Environmental Review Team Report

# Evergreen

Chester, Connecticut

October 1984

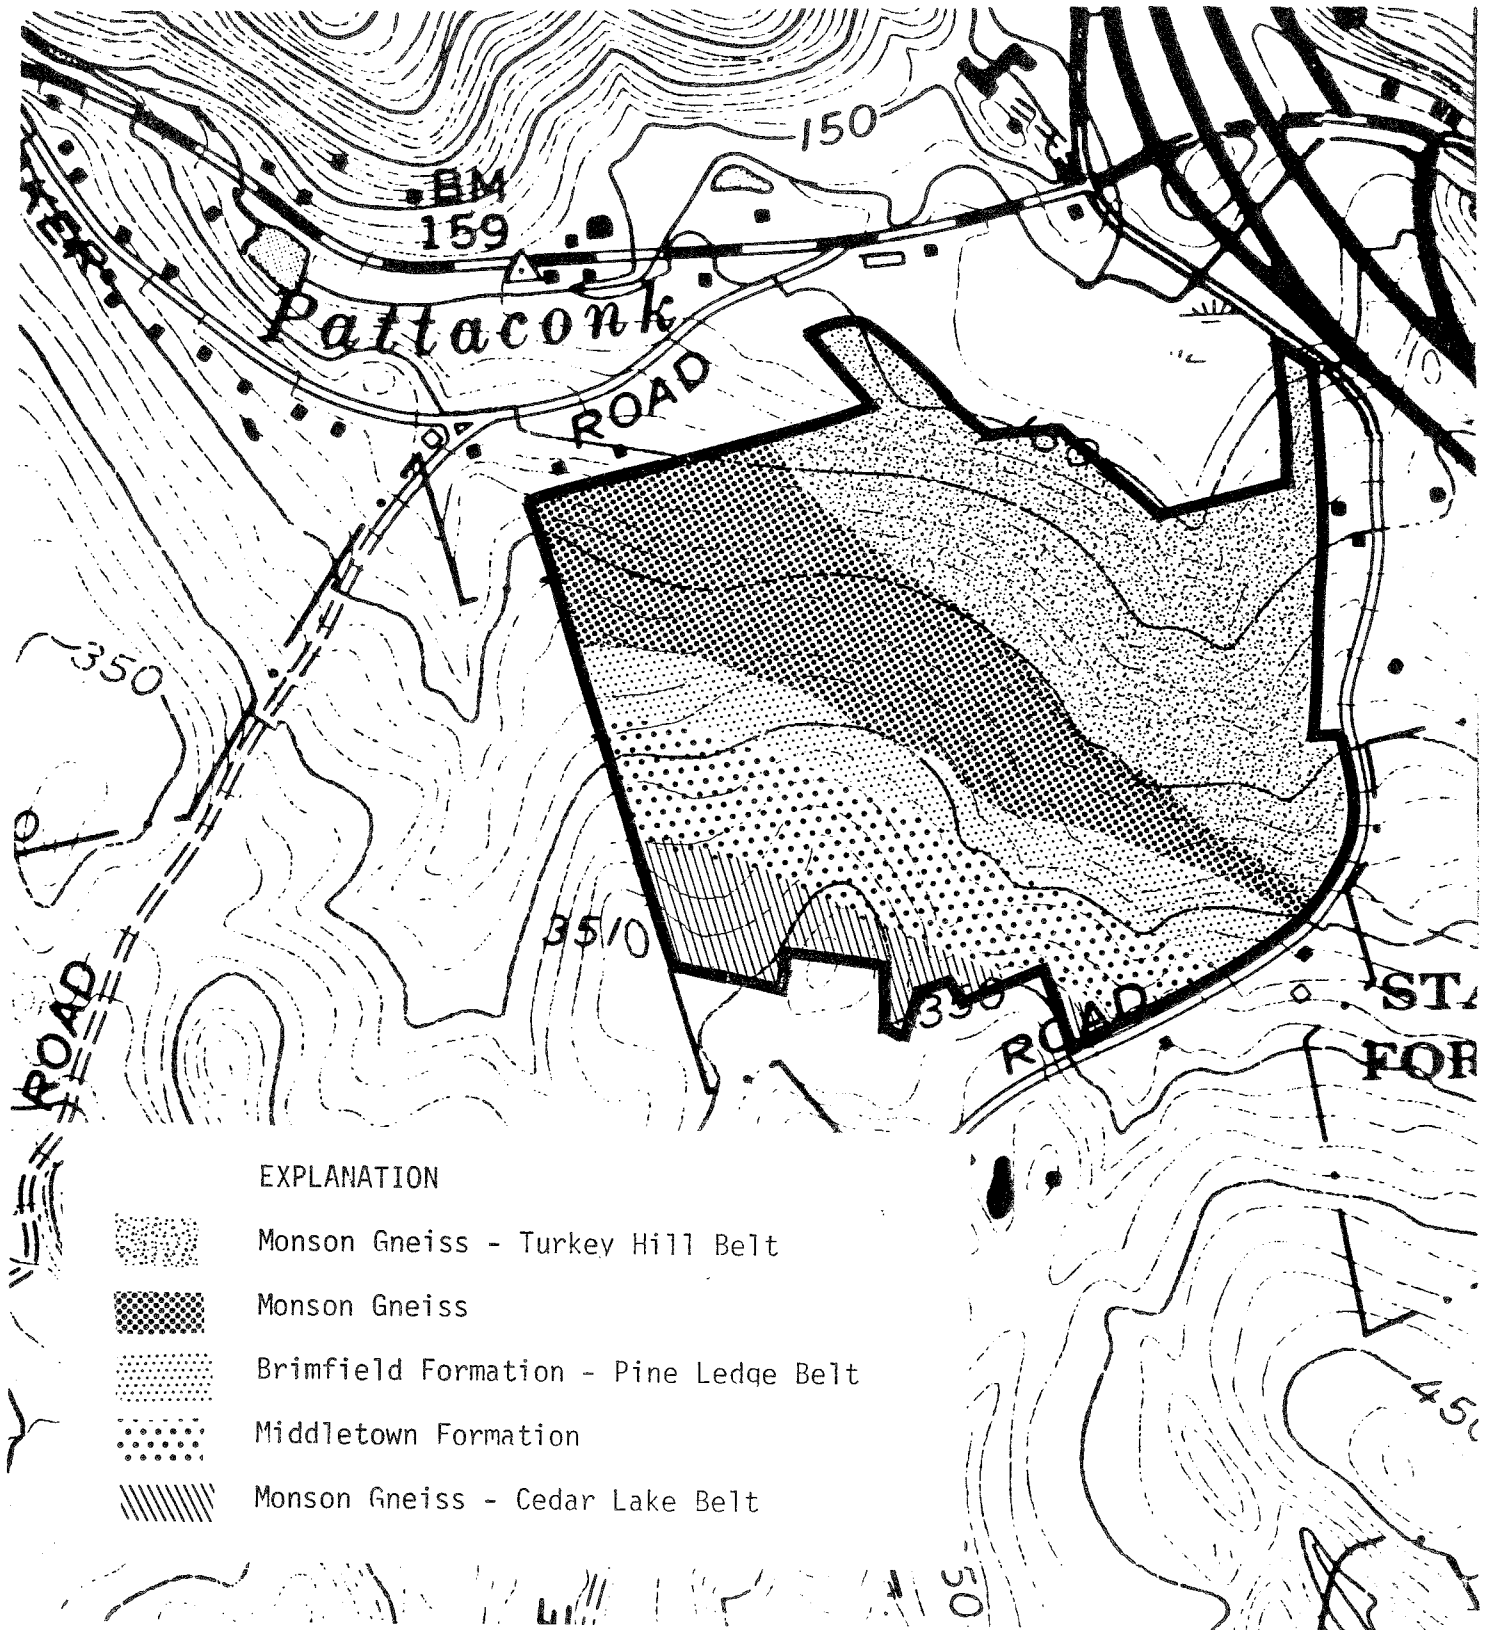
Preliminary plans dated September 23, 1984, show 25 lots of two or more acres each. On-site septic systems and wells will be needed to serve each lot. A single roadway will extend north into the property from Hoopole Hill Road, terminating in a cul-de-sac, to provide access to interior lots. The development will be known as "Evergreen."

The Team is concerned with the effect of this proposal on the natural resource base of this site. Although many severe limitations to development can be overcome with proper engineering techniques, these measures can become costly, making a project financially unfeasible for a developer. Slope, wetland areas and seasonally high water tables are the major limiting factors on this site. The large lot sizes, however, appear to have left sufficient area to work around these limitations. Wetland crossings will be needed for the driveways on lots 4 and 5, as well as for Evergreen Hill Drive near lot 21. Sediment and erosion control measures should be in place prior to construction of these crossings.

There are several concerns with the access road to this site. The sight distance at Hoopole Hill Road is difficult because of the curve in Hoopole Hill Road at that point. The two sharp curves in the proposal for Evergreen Hill Drive cause dangers for driving and sight distance problems for driveways in the vicinity of those curves. The 2900 foot length of the road is longer than is advisable for a cul-de-sac. A cul-de-sac of this length brings about potential problems with emergency vehicle access that are more serious than for a road with two points of access. The Connecticut River Estuary Regional Planning Agency recommends a maximum cul-de-sac length of between 700 and 1000 feet depending on topography. The last 600 feet of the proposed road climbs a steep slope and it appears that even the cul-de-sac itself would be built on a slope. This causes difficult driving in the winter and the extensive use of road salts which can pollute the wetlands and seasonal brooks that are located on this site.

The development of a good road design for this site is made difficult by the wetlands and steep slopes on the site and the limited access that this site has to the existing road network in the area. The Town should work with the developer to see if the road design can be improved so that it better addresses the design problems noted above and the natural features of the site. The following are points suggested for discussion:

1. Clear an area along Hoopole Hill Road in order to maximize the sight distances for the proposed road. The Connecticut River Estuary Regional Planning Agency recommends the following minimum sight distances based on design speed of the road.

2. Increase the radius of the curves in Evergreen Hill Drive in order to reduce the danger of the sharp curves that are proposed.

3. Provide safe sight distances for driveways by locating them properly and clearing vegetation as necessary. The sight distance standards for driveways recommended by the Connecticut River Estuary Regional Planning Agency are included in the following table.

4. Move the cul-de-sac at the end of the road to the level area just above the present location of this cul-de-sac.

5. Have the applicant develop alternative road designs that would deal with the problems noted earlier in this section.

# Drainage Areas

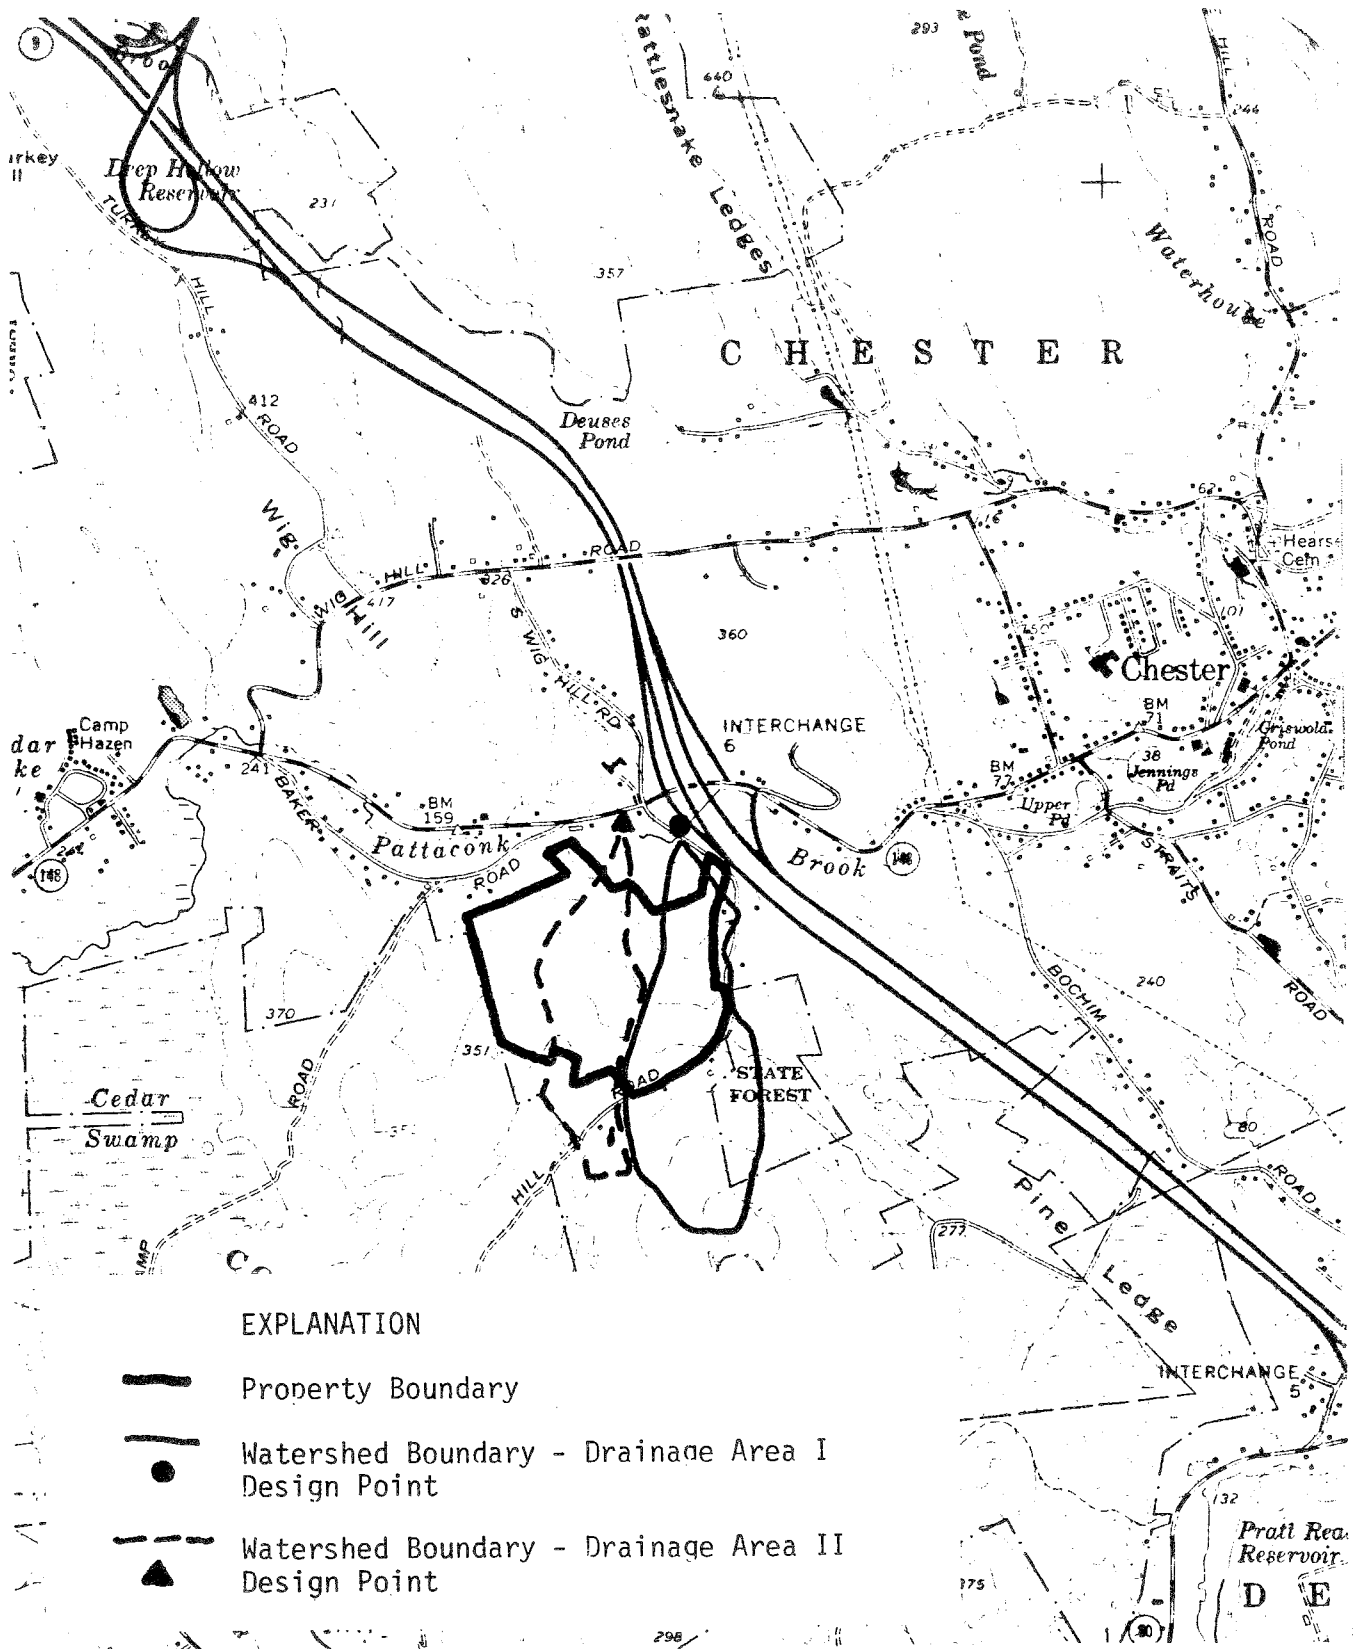
Storm water increases will arise primarily from the conversion of pervious soils to impervious surfaces such as roofs, paved roads and driveways, compaction of soils during the construction phase, and from the removal of vegetation.

Estimates were made of runoff and peak flow increases that would be experienced following development. These estimates have been prepared for a 1- year, a 50 year and a 100 year storm. Peak flows were calculated for the point at which each stream discharges into Pattaconk Brook. The two design points and their corresponding watersheds are shown in the accompanying Drainage Area Map. The method used to make these estimations is described in Technical Release No. 55 of the Soil Conservation Service. Lot 8 is not included in the drainage calculations because it does not fall in either watershed. Peak-flow increase from this lot alone should be insignificant. It was assumed that houses constructed on lots 18-23 would fall within drainage area II. Results are given in tables. It must be remembered that the estimates in the tables are meant only to indicate the prospective magnitude of the increases; they are not designed to indicate absolute flow rates (which may be significantly greater or less than the corresponding estimates) nor should they be used as engineering data.

As the figures given above suggest, peak flow increase to Pattaconk Brook from each watershed analyzed may be expected to be moderate following development. These increases may be explained by the percentages of impervious surfaces planned on each lot and by the piping of runoff. The increase would be especially critical in view of the moderate to steep slopes on the site. These conditions may create a risk of erosion along banks of streams traversing the parcel thereby increasing siltation to downstream areas.

The Town has indicated to Team members that they would like to see off-site flows following the development be maintained at present levels. The most likely resolution for controlling peak-flows would be the installation of one or more detention basins. A detention basin(s) might also be constructed to serve a sediment retention function. Prior to subdivision approval, it is recommended that the applicant be required to submit detailed hydrological information on pre- and post-development peak flows from the site. Estimates should be provided for a 10, 25, 50 and 100 year design storm. In addition, hydraulic calculations should be prepared to justify culvert sizes. If storm-water control facilities (detention basins) are installed, detailed design specification should also be submitted. All storm drain outlets should include a designed energy dissipator or help protect areas below the outlet from eroding.

# Vegetation

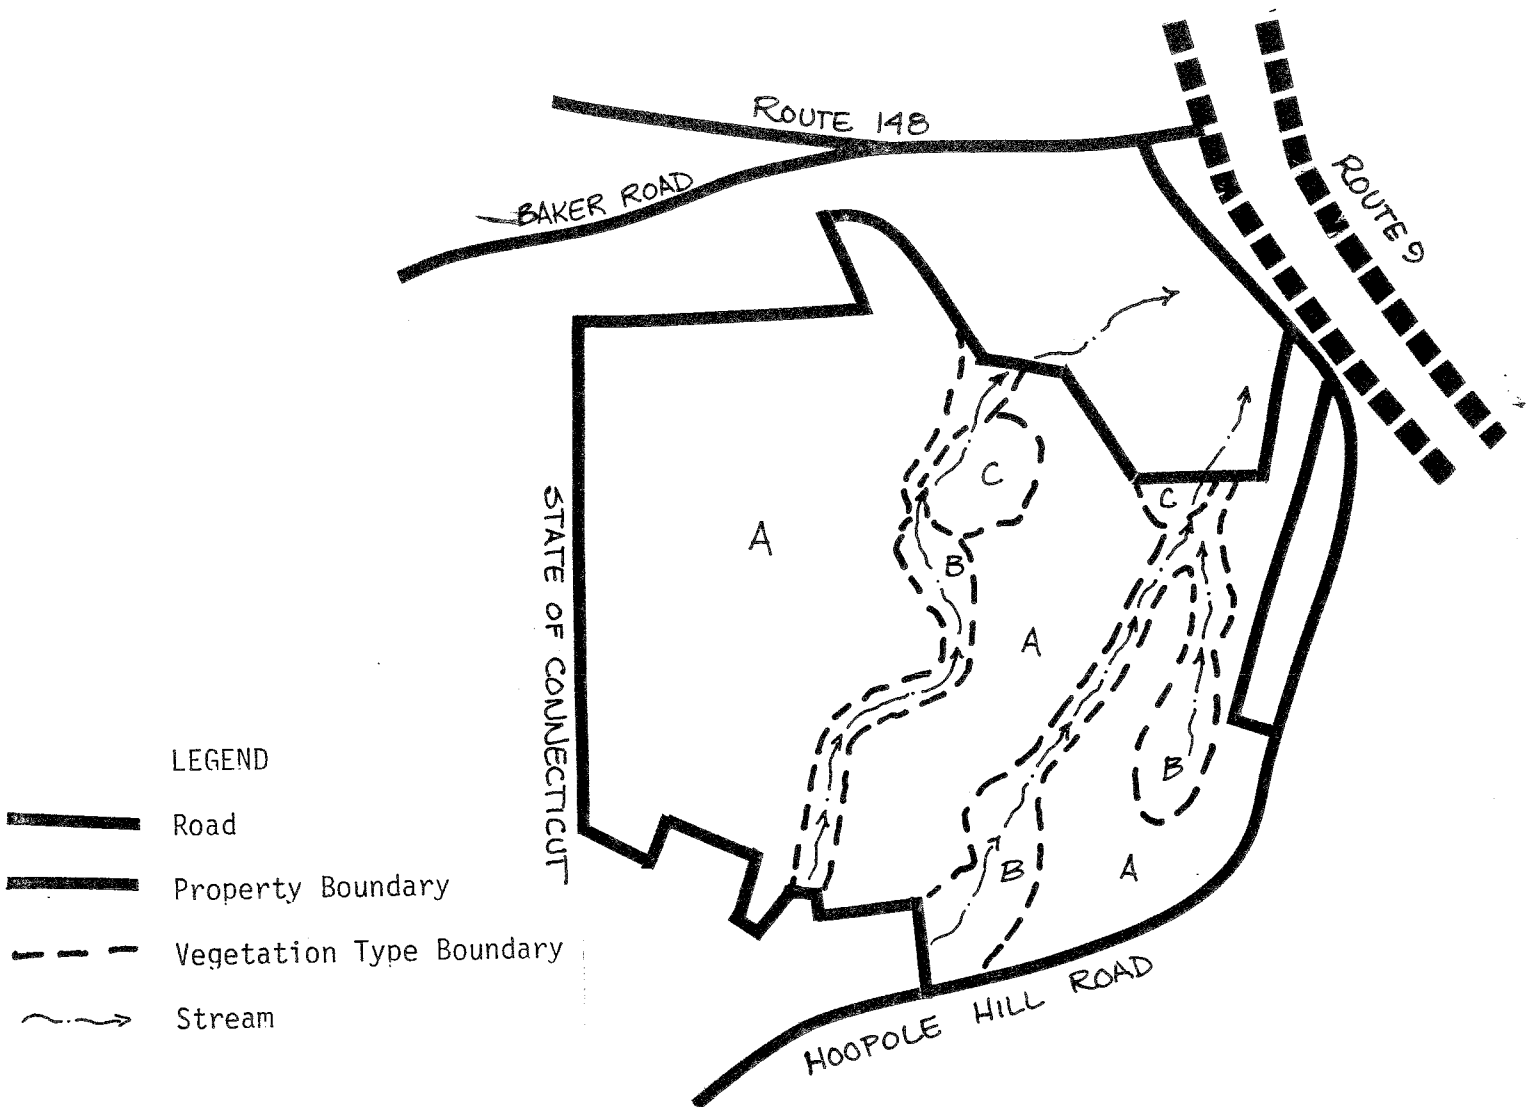
STAND A: (Mixed Hardwoods-76 acres) Two aged. Fully stocked, Pole and Sawtimber size, healthy as is. Poor quality pole size trees could be removed to improve aesthetics.

STAND B: (Stream Belt - 15 acres) Fully stocked, pole to sawtimber size, healthy as is.

STAND C: (Hemlock - 4 acres) Fully stocked, all size, hardwoods could be removed for fuelwood to release crowding.
